AGENDA
CONCEPTUAL PLAN REVIEW COMMITTEE
Community Room, 3rd Floor
Arlington Heights Village Hall, 33 S. Arlington Heights Rd.
Arlington Heights IL 60005
July 23, 2025
6:30 PM

Item: 5 N. Douglas Ave. - T1882
Planned Unit Development, Land Use Variation for Multi-Family building in B-2 District, Subdivision

VILLAGE OF ARLINGTON HEIGHTS STAFF DEVELOPMENT COMMITTEE REPORT

Temp File Number: T1882
Project Title: 5 N. Douglas
Address: 5 N. Douglas
PIN: 03-29-408-002 and 03-29-405-005

PC1-1.2

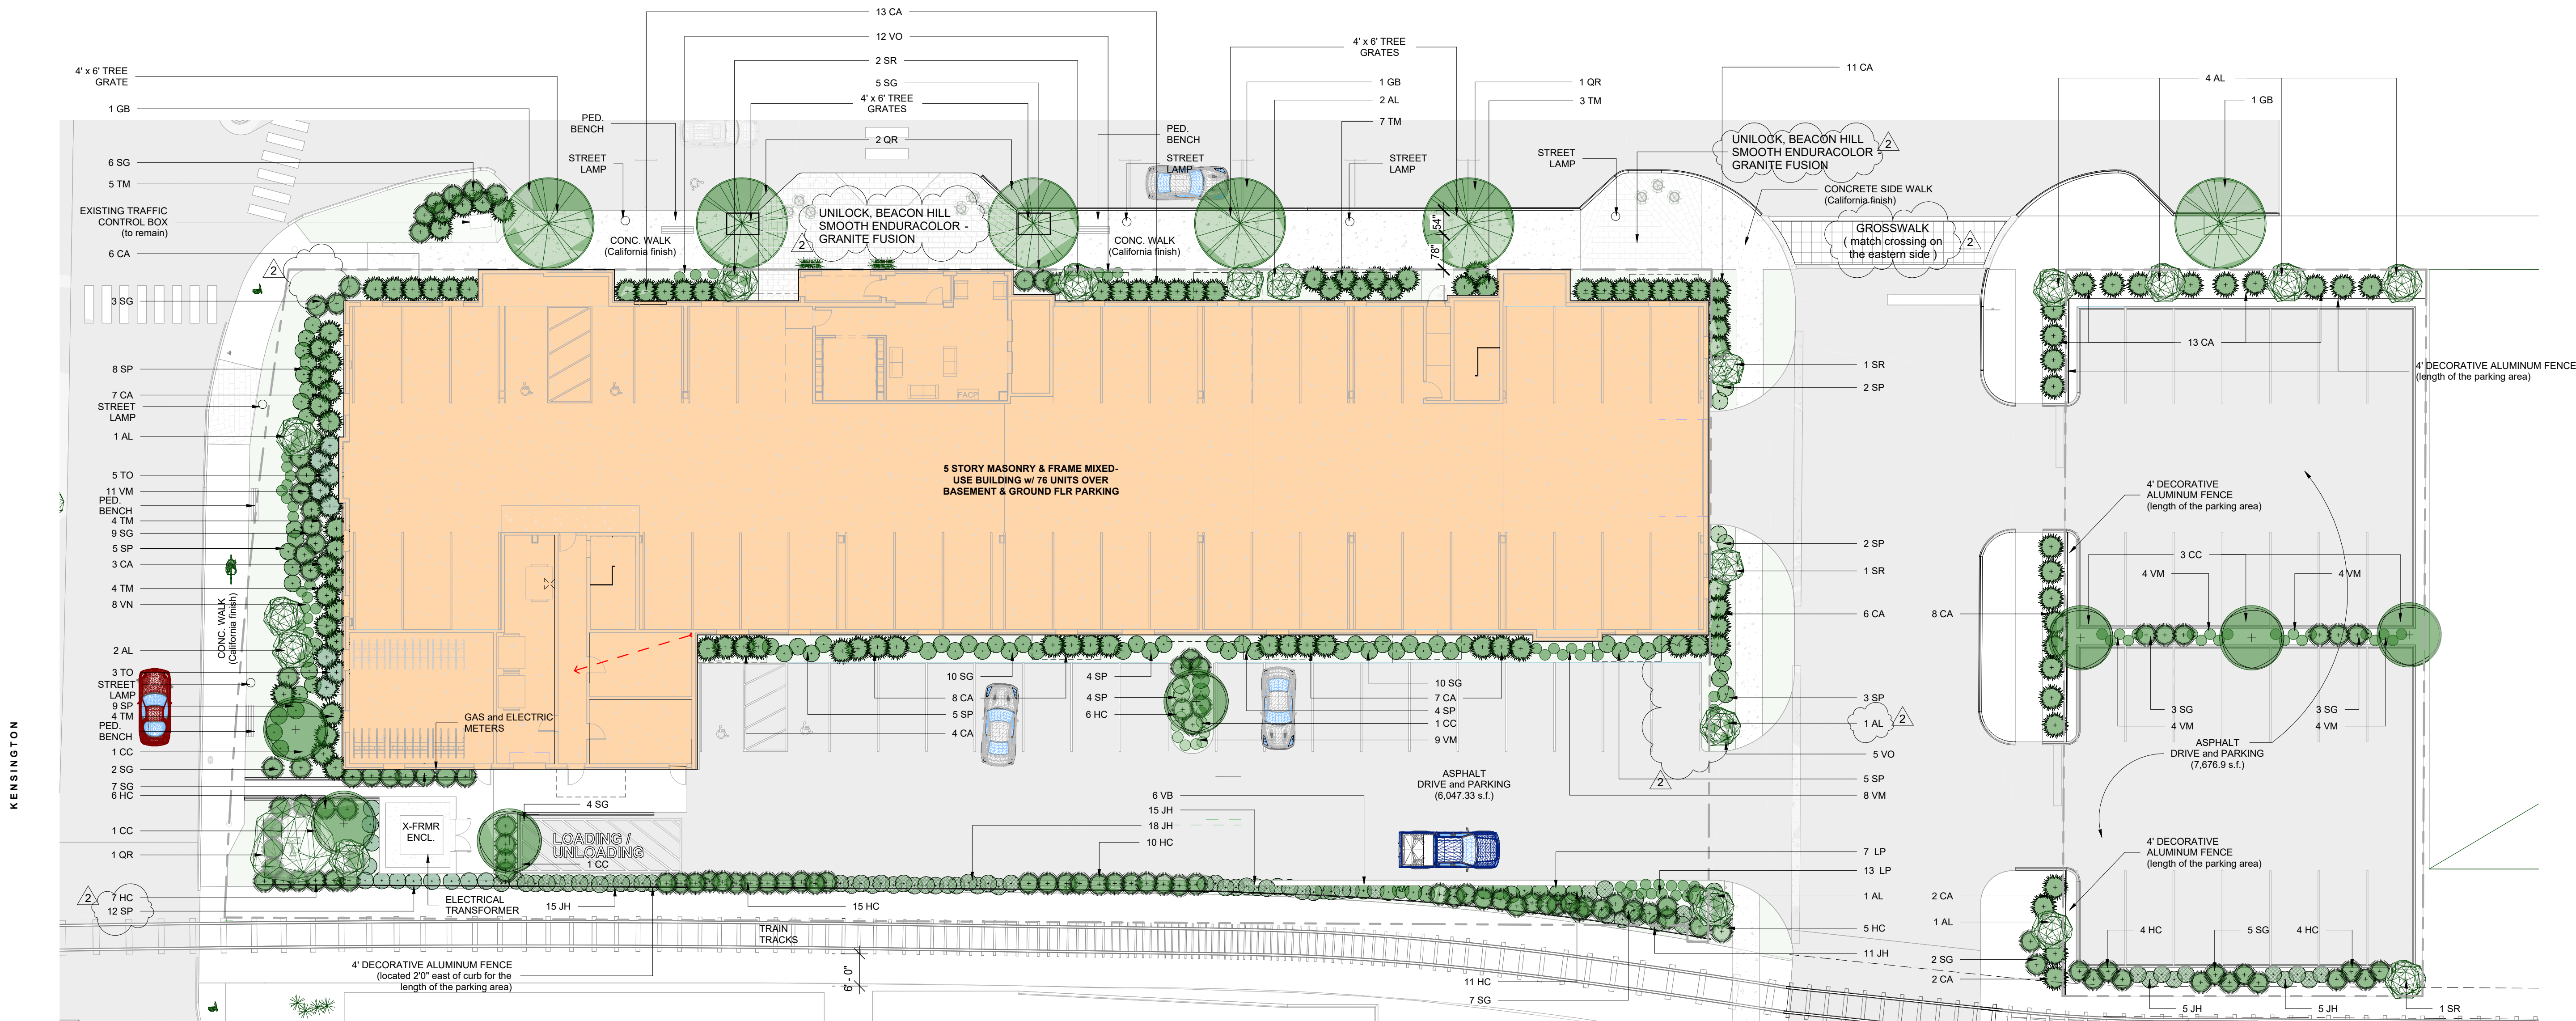
A code compliant Landscape and Tree Preservation Plan will be required within any formal Plan Commission application, including building foundation plantings, landscape islands within the parking lot at the ends of each parking row, and shade trees in all parking lot islands.

1 FIRST FLOOR
PC2-1.1 SCALE: 3/32" = 1'-0"

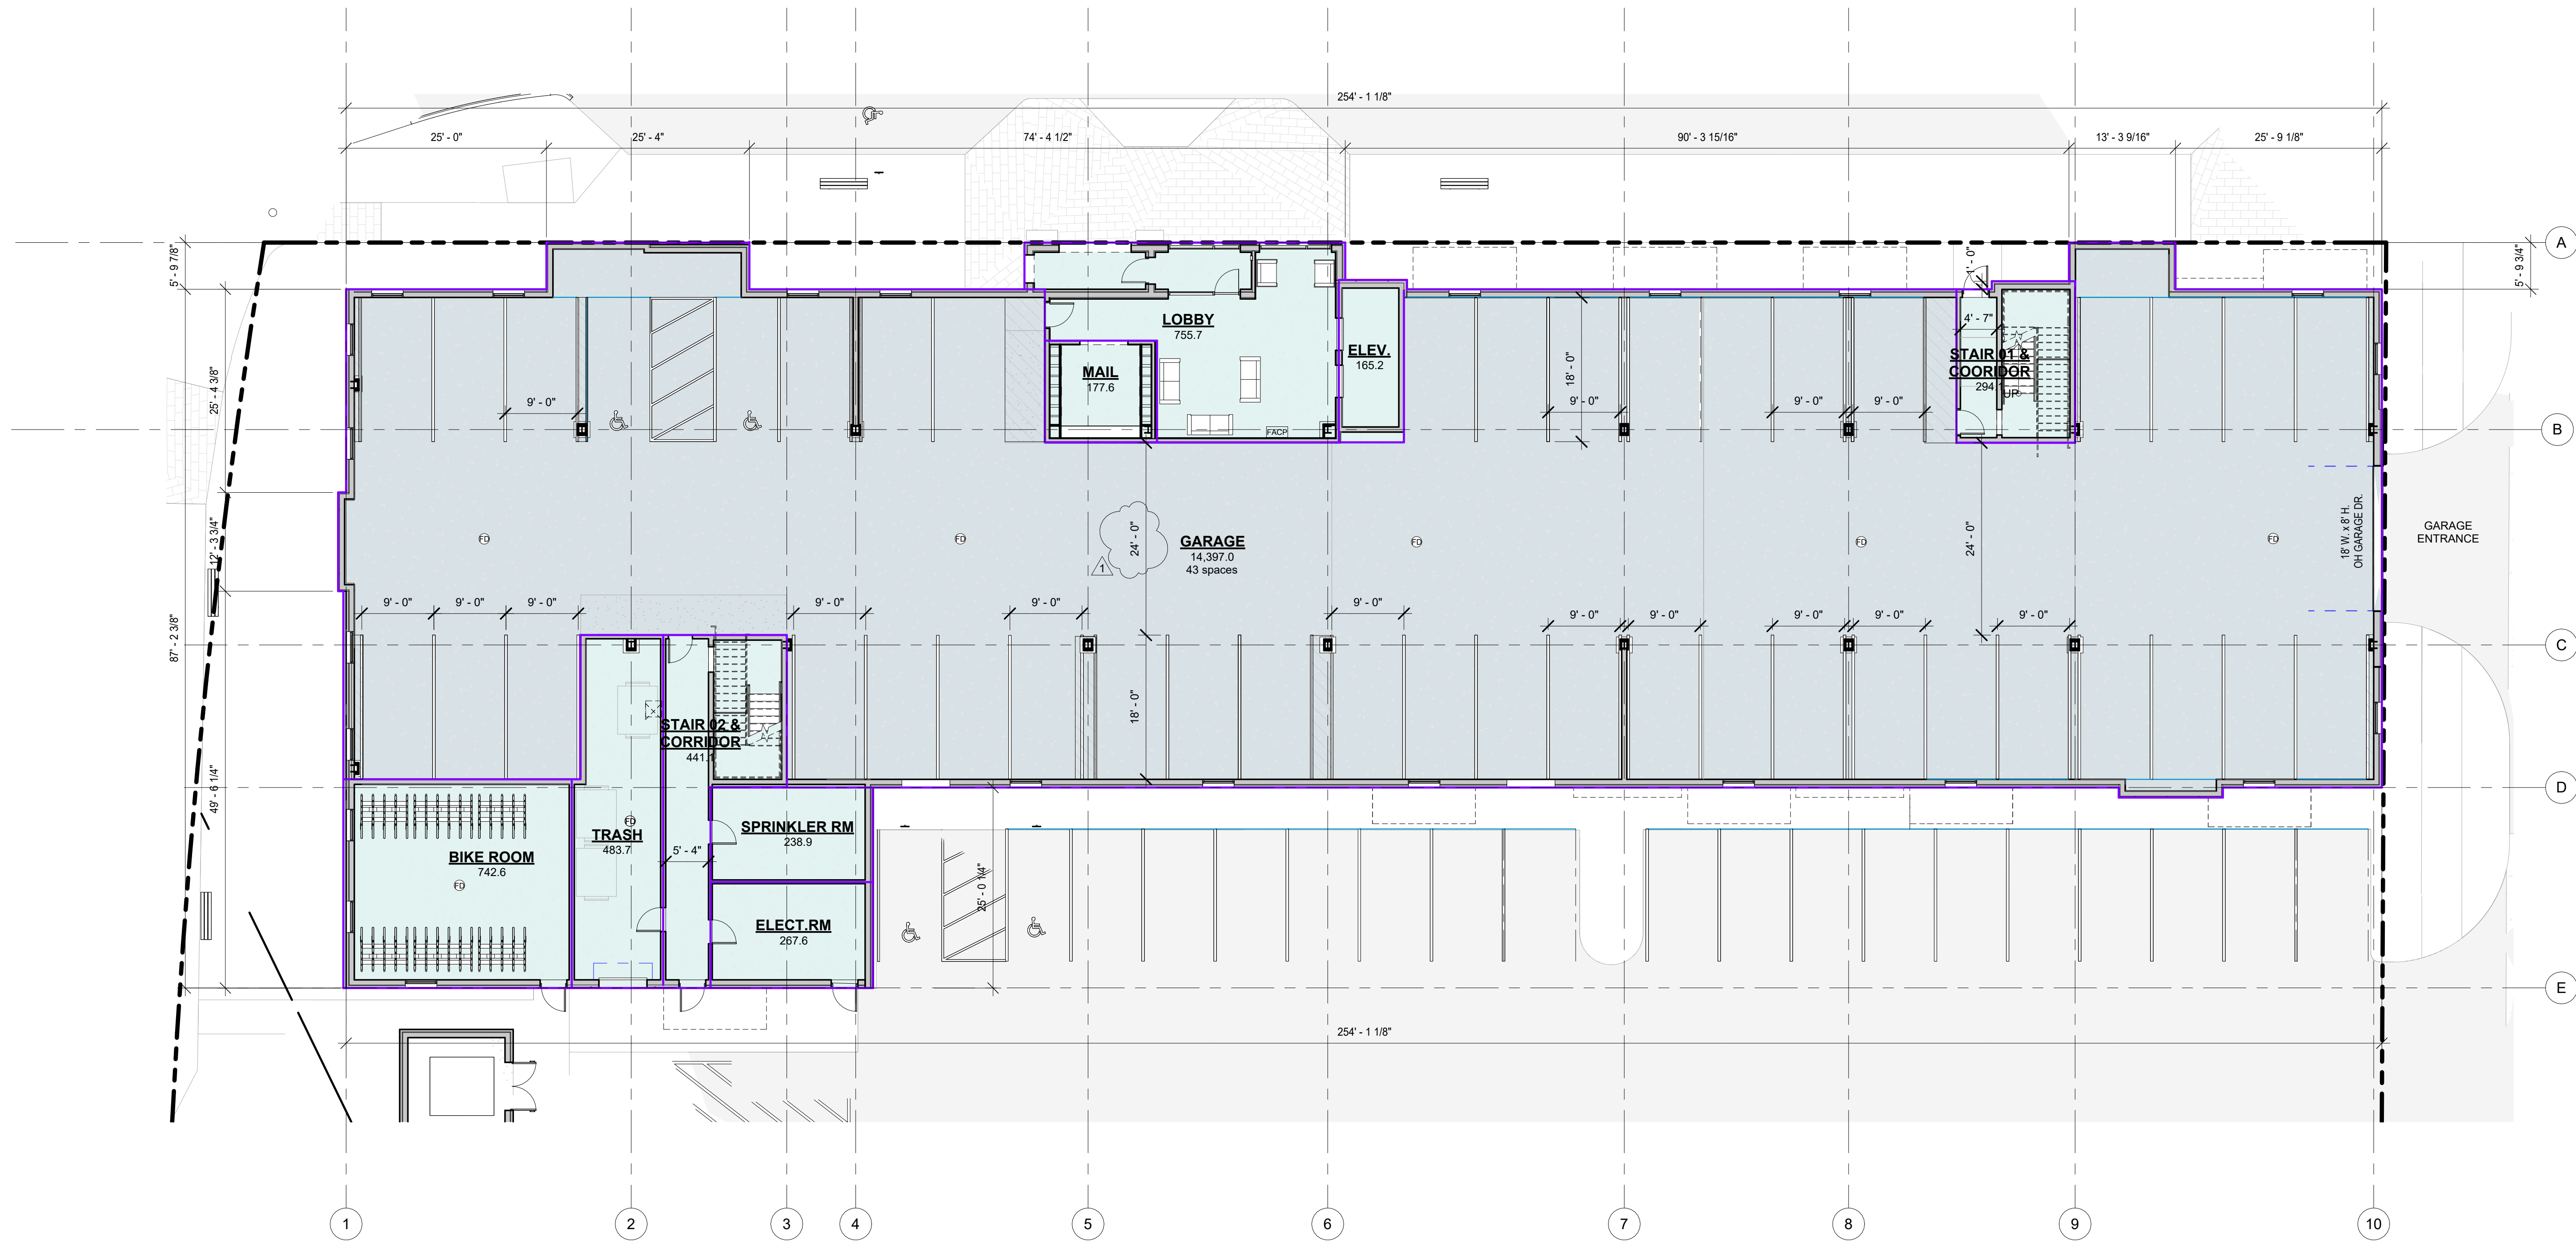
11. Consider revising the design/access to the southernmost stalls in the surface parking lot under the building.
12. The 4 N Hickory Development has been completed since staff last reviewed this application in October, 2023. The sidewalk for 5 N Douglas Ave shall align with the sidewalk east of the spur at the direction of Village staff.

19. It does not appear that the cars parked on the south end of the garage will be able to reverse out. Consider striping those spaces as no parking or increasing the bump out.

21. Handicap spots should be relocated closest to the elevator.
